Re: Russell Fabrication/Shenton Property
C 08-0012, G 02013310

Thank you for forwarding revised plans for the above-referenced project for review. The applicant proposes to construct a new commercial building and parking lots on an existing 0.77 acre parcel. The property is classified as an Intensely Developed Area (IDA). Since the meeting with Commission staff and the comments in my August 31, 2009 letter, the applicant has incorporated Commission staff recommendations into the revised plans. I have provided one remaining minor comment on the project below:

Re: Name: Russell Fabrication
Site Development Plan: C # 2008-0012-00NC
Grading Permit # G02013310

DATE: December 8, 2009
TO: Dan Gerczak – Planner II
FROM: John F. Bassford Jr., PE – Engineer III
SUBJECT: Russell Fabrication
SDP C#08-0012
Permit #G02013310

SHEET 2 OF 7
 SITE DEVELOPMENT PLAN

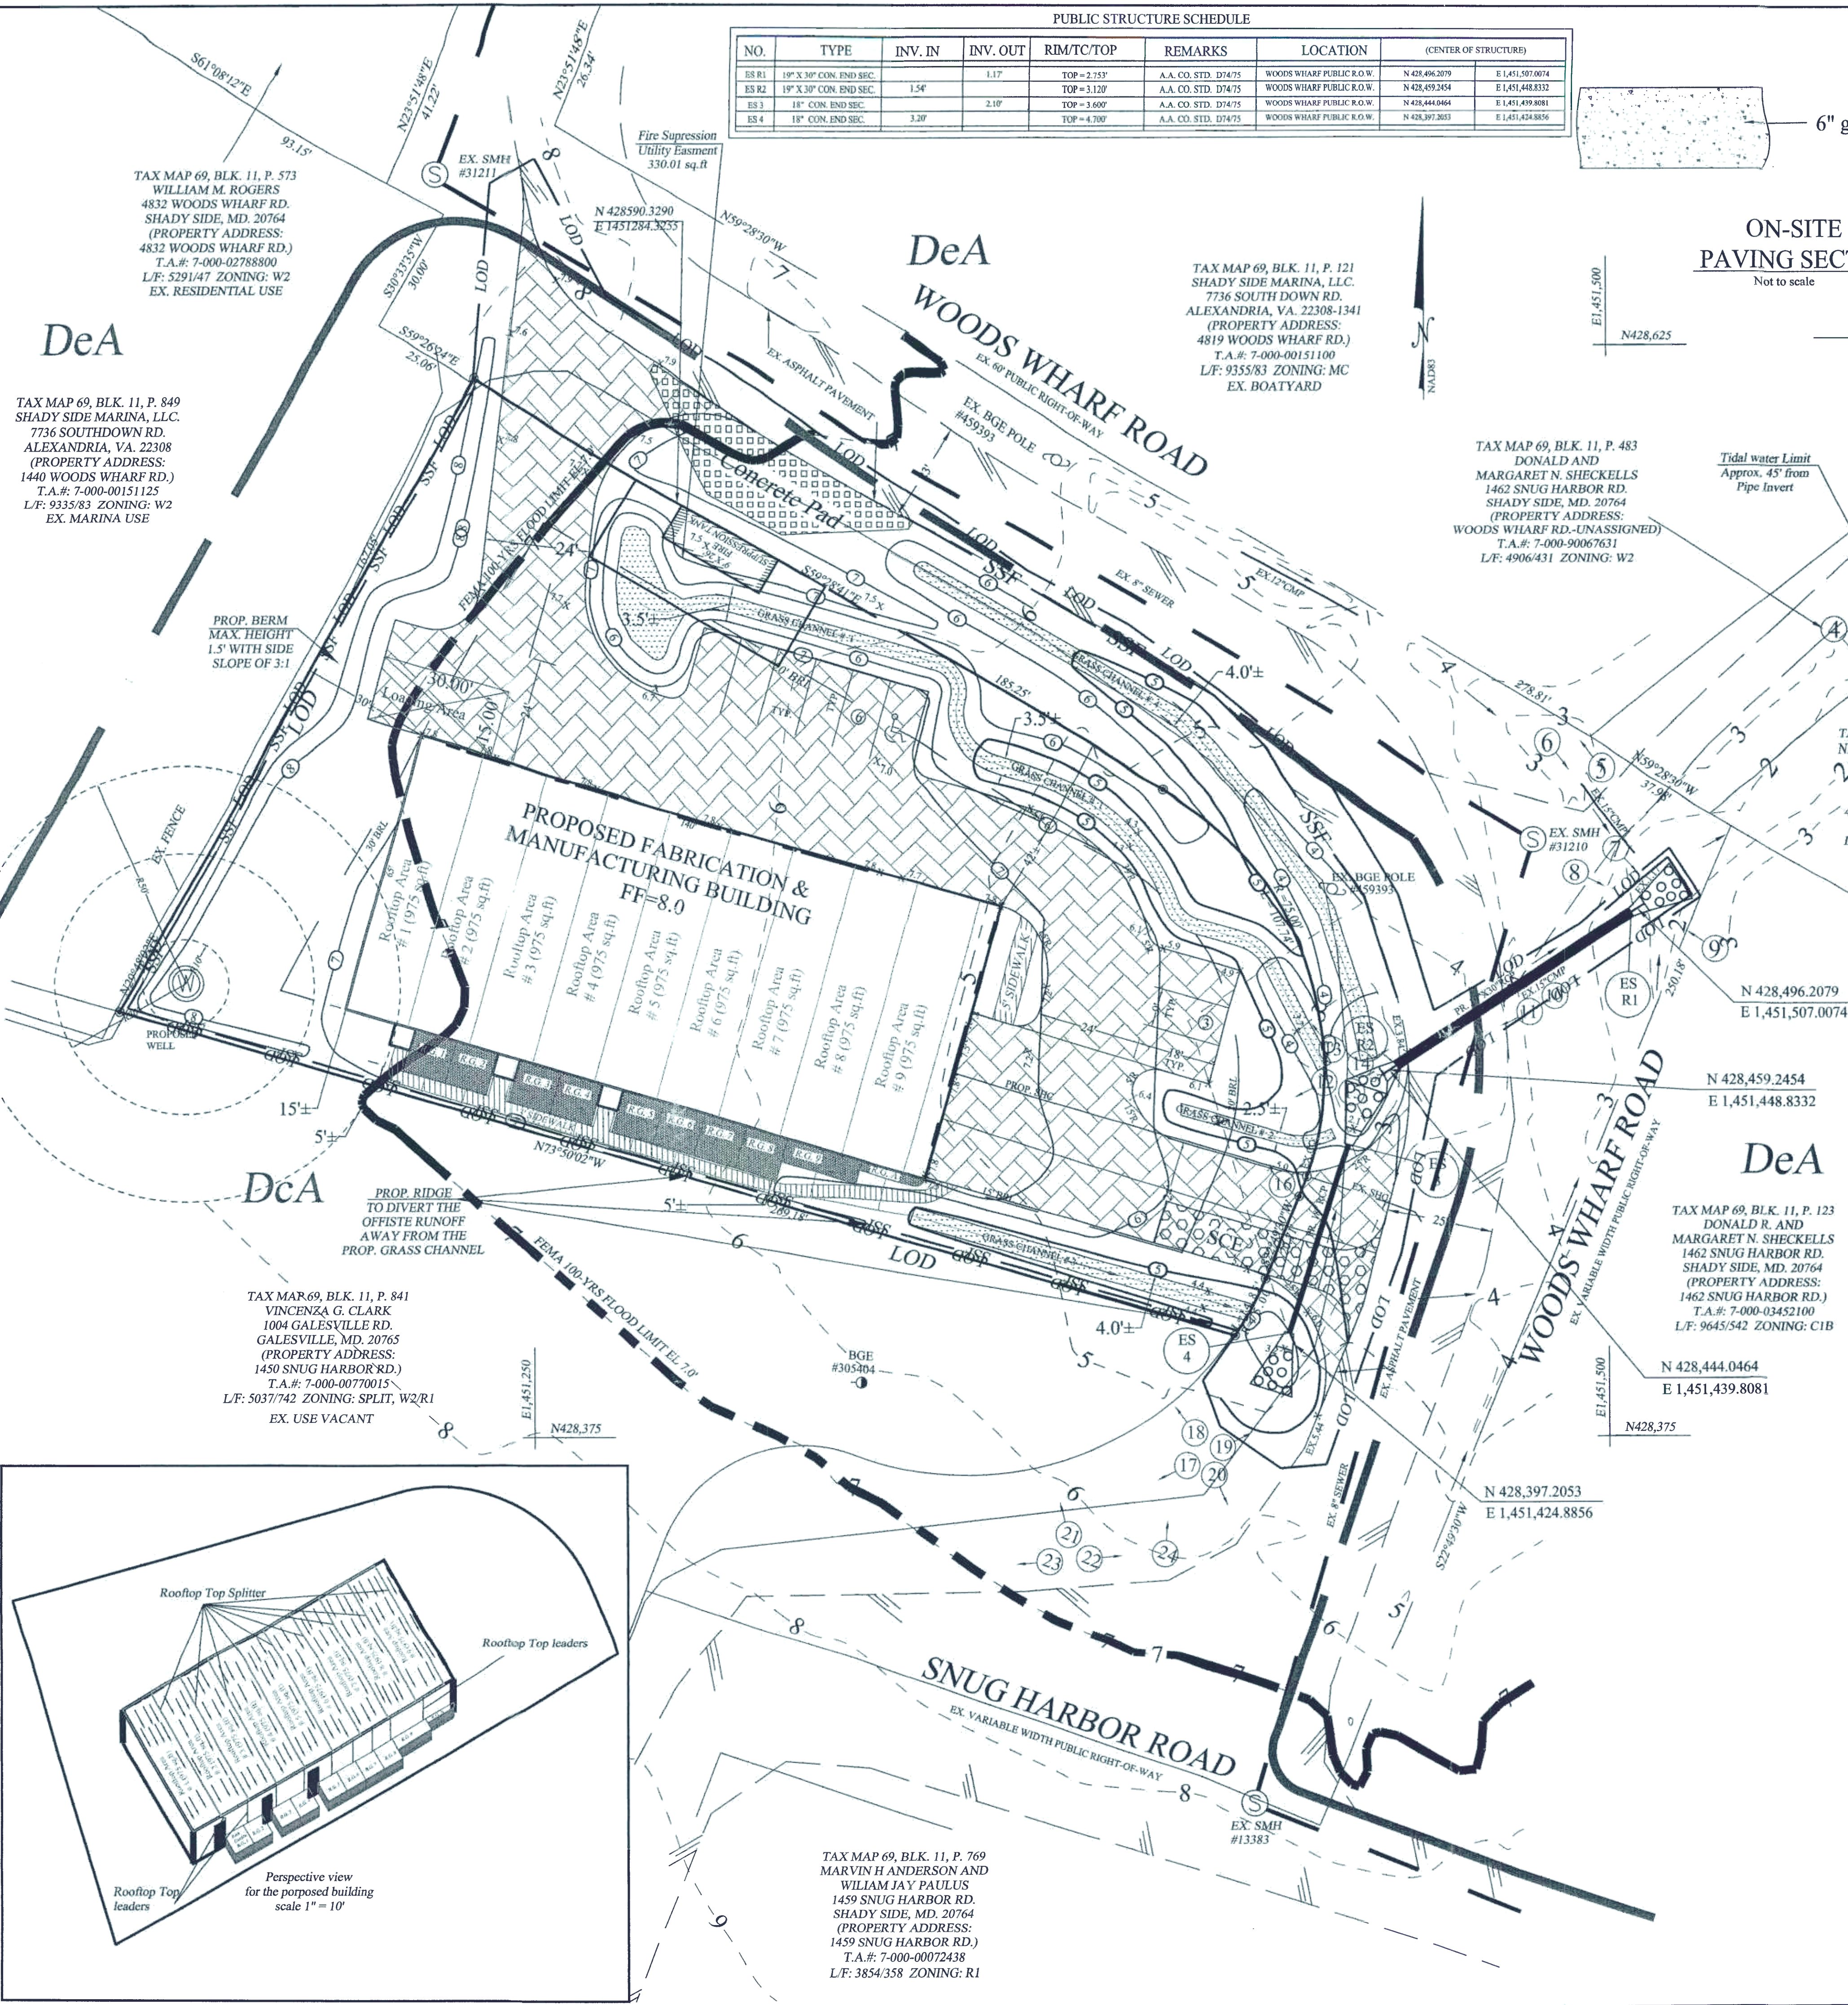
2. Previous comment #C.2 has still not been adequately addressed. The computations provided for the grass channel credit are now consistent with plan view on Sheet 2 of 6, but are not consistent with the SWM Concept notes on the same sheet. Each grass channel now has a unique design cross-section. Indicate all three unique cross-sections on the plan.

5. In regards to previous comment #C.4, the SWM Concept Note (on Sheet 2 of 5) makes reference to use of the Non-Rooftop Disconnect Credit. Where is this credit being applied? The grass channels are designed for the Grass Channel Credit. Clarify.
6. Provide a detail of the building roof showing how the 975-sf areas are being divided and distributed to the raingardens. The detail will also need to be part of the architectural plans, and the architectural plans will need to be submitted to the Public Works reviewer at time of building permit for verification.
7. Provide full construction and planting details for the proposed raingardens.

RUSSEL FABRICATION ANNE ARUNDEL COUNTY, MARYLAND		RECEIVED NOV 02 2009
SCALE: AS SHOWN	APPROVED BY:	DRAWN BY: WMC/A COMMISSION
DATE: OCTOBER, 2009	CHECK BY: RJ	PROJECT NO.:
SHEET 6 OF 7		POI DRAINAGE AREA (EXISTING CONDITIONS)
SCALE: 1" = 100'		AA27DRAINAGE

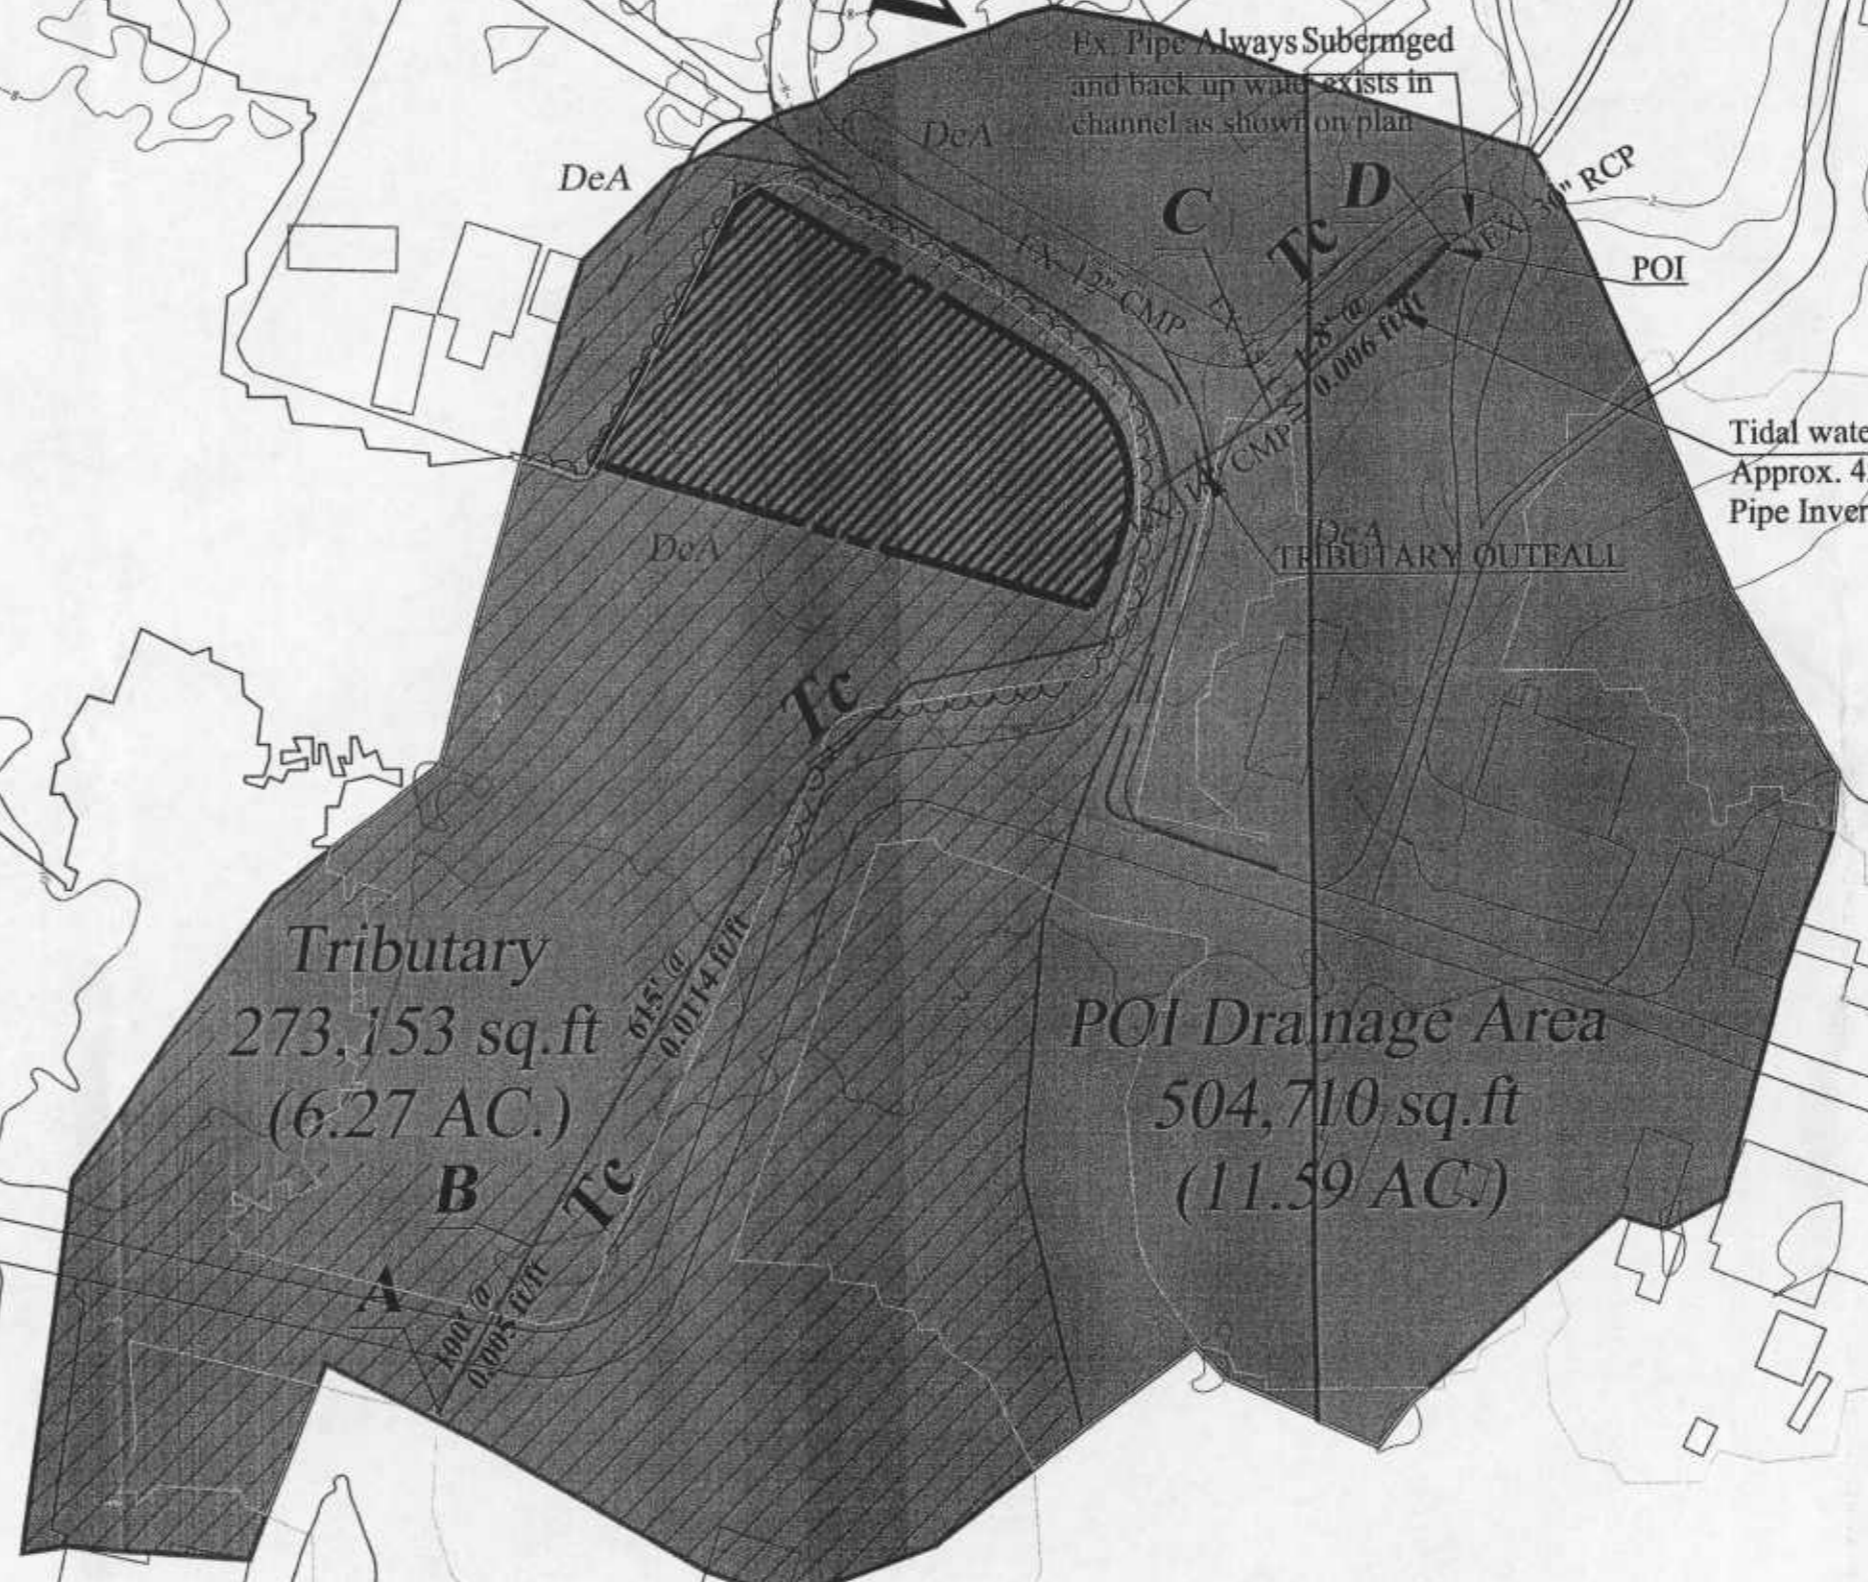
1. Previous comment #C.1 has still not been adequately addressed. Refer to comment #B.1 above. The Site/Tributary Outfalls and the POI locations have been shown on Sheet 5 of 6. However, the existing and proposed condition drainage area maps are still not at the same scale (Sheet 4 of 6 is 20-scale, Sheet 6 of 6 is 40-scale), and the proposed conditions map shows no proposed features. Revise.
